**ST. TAMMANY PARISH**

**Addendum No.: 3**

**Bid#: 24-10-2**

**Project Name: Highway LA-21 Lift Station**

ELECTRICAL PLAN

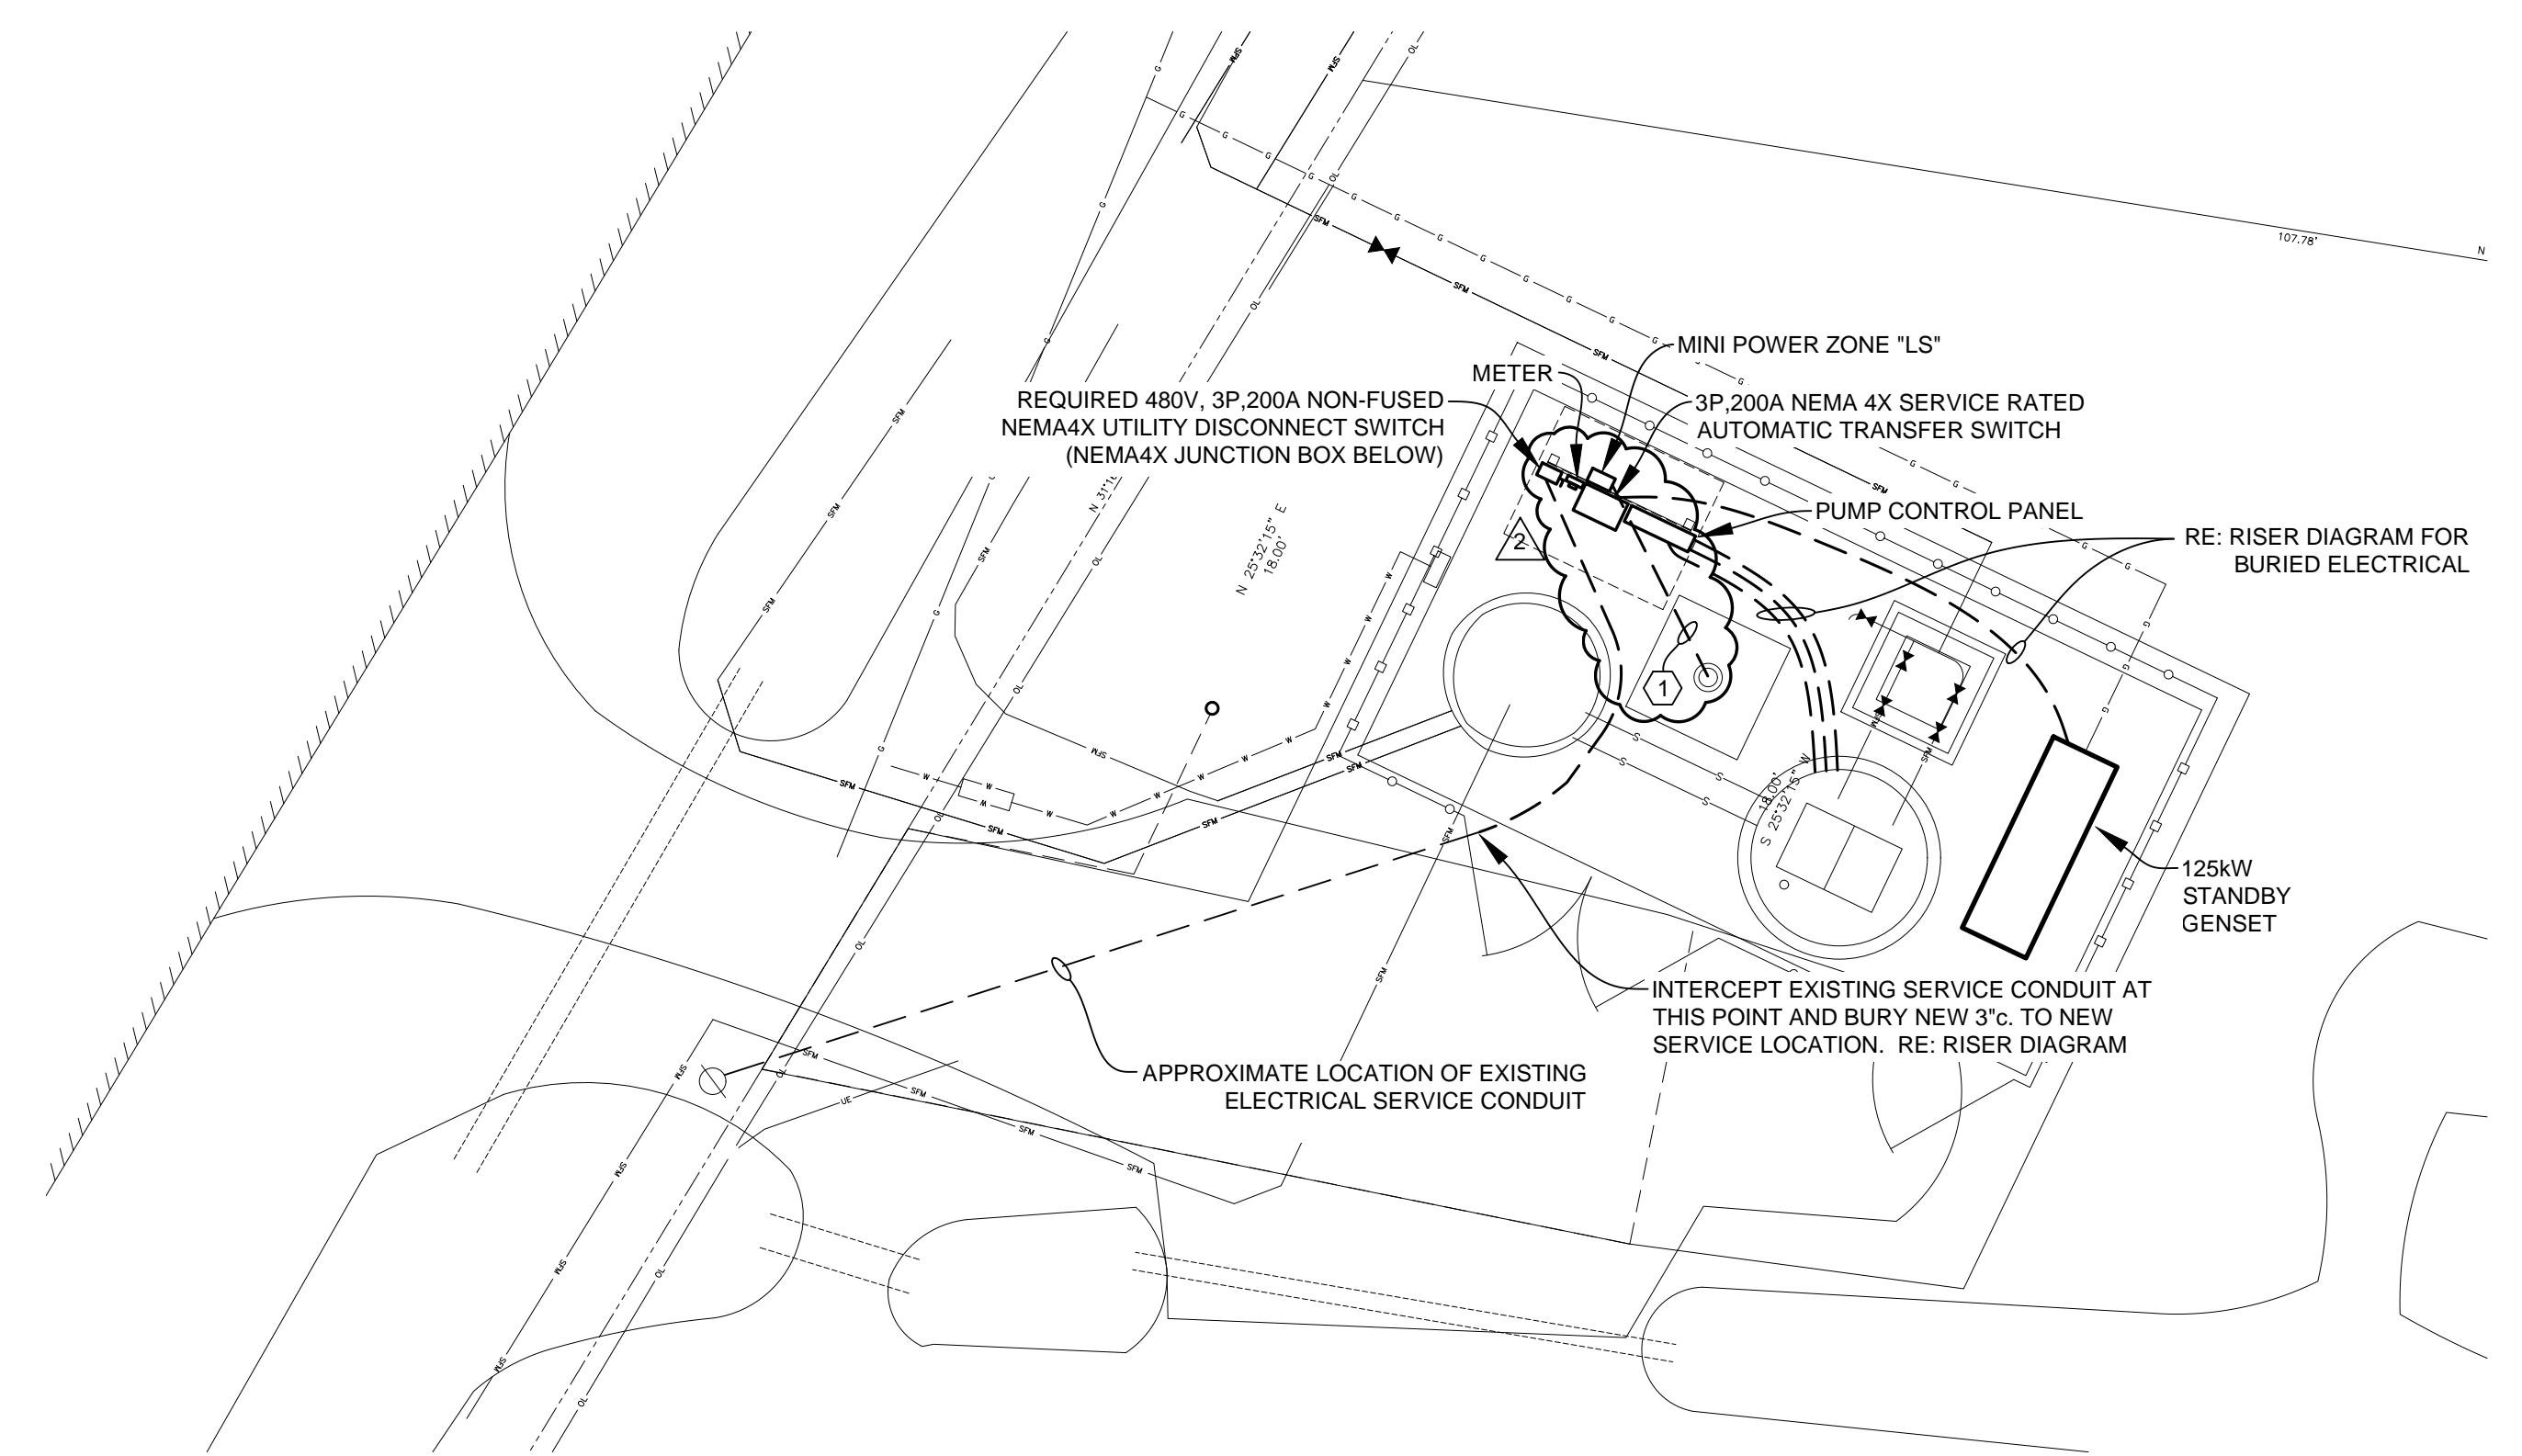
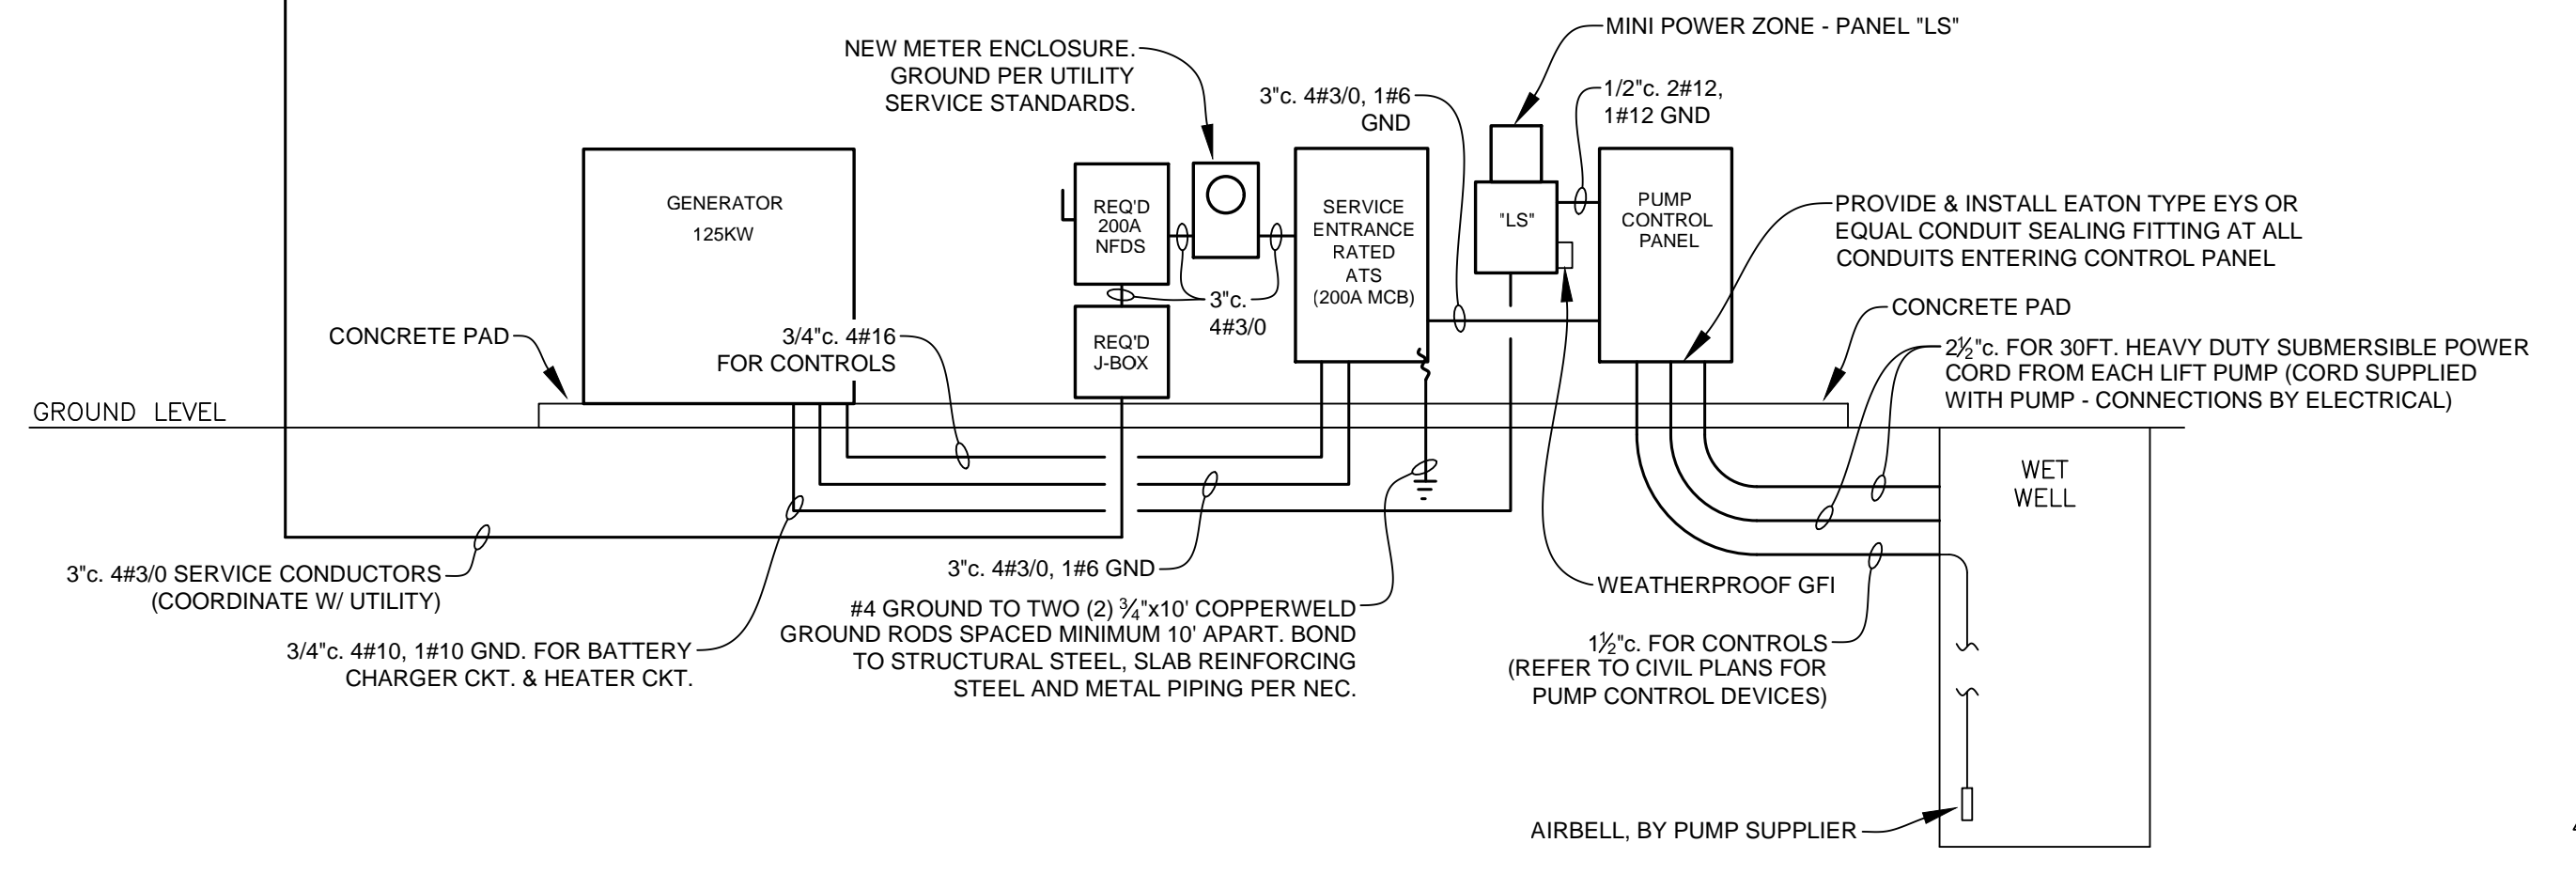
Drawing Revision: Sheet 46 – Electrical Plan has been revised to revise table and include notes for the required electrical work to the electric chain joist equipment. See 46 – Electrical Plan for more details, in this Addendum below.

- Add rows ‘Panel: “LS”’ table for electric chain hoist
- Add ‘Specific Notes’ for conduit and electrical wiring for electric chain hoist controls:

“BURY 3/4" c. 4#10, 1#10 GND. FOR CIRCUIT LS-6 AND ADDITIONAL CIRCUIT FOR FUTURE POWER ROTATION. RUN UP INTO BASE OF JIB CRANE AND PROVIDE WEATHERPROOF JUNCTION BOX FOR TRANSITION TO FLEXIBLE POWER CORD. PROVIDE FESTOON GLIDERS AND TRACK AS NECESSARY TO SUPPORT THE FLEXIBLE POWER CORD ALONG THE JIB BOOM AND ACCOMMODATE THE RANGE OF THE ELECTRIC HOIST.”

- BURY 3/4" 4#10, 1#10 GND. FOR CIRCUIT LS-6 AND ADDITIONAL CIRCUIT FOR FUTURE POWER ROTATION. RUN UP INTO BASE OF JIB CRANE AND PROVIDE WEATHERPROOF JUNCTION BOX FOR TRANSITION TO FLEXIBLE POWER CORD. PROVIDE FESTOON GLIDERS AND TRACK AS NECESSARY TO SUPPORT THE FLEXIBLE POWER CORD ALONG THE JIB BOOM AND ACCOMMODATE THE RANGE OF THE ELECTRIC HOIST.
